REMARKS

Drawings

Fig. 6

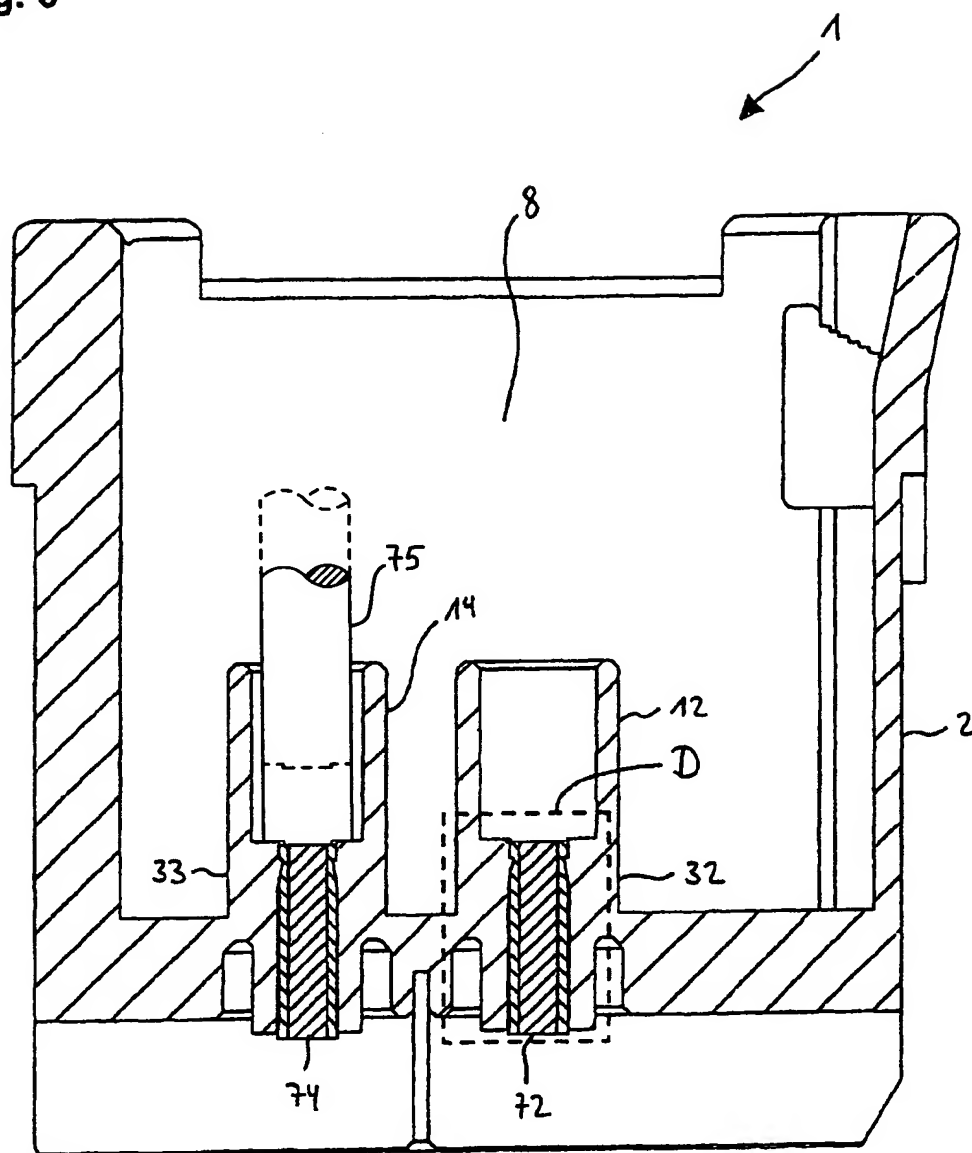
FIG. 6: Please cancel sheet no. 6 and substitute amended replacement sheet no. 6. The foregoing amendment adds a showing of mounting die 75 fully inserted to working position (solid lines) and as partially retracted (phantom line). These corrections are shown in red ink in the accompanying copy of FIG. 6 on sheet 6 of the drawings as filed.

Amended FIG. 6 shows the mounting die (now numbered "75") described in the specification at Page 5, Lines 30-33 and Page 6, lines 1-30 as filed, and also referenced in claim 25 as filed. This therefore overcomes the Examiner's objections to the Drawings, i.e., that the mounting die feature be shown as referenced in claim 25, without adding new matter. The description of FIG. 6 has also been amended to conform to this drawing amendment.

Paragraph [0086] has been revised in view of the amended showing of FIG. 6 with mounting die 75 added. For disclosure in support of this amendment, in addition to claim 25, see also published application paragraphs [0033], [0034] and [0037].
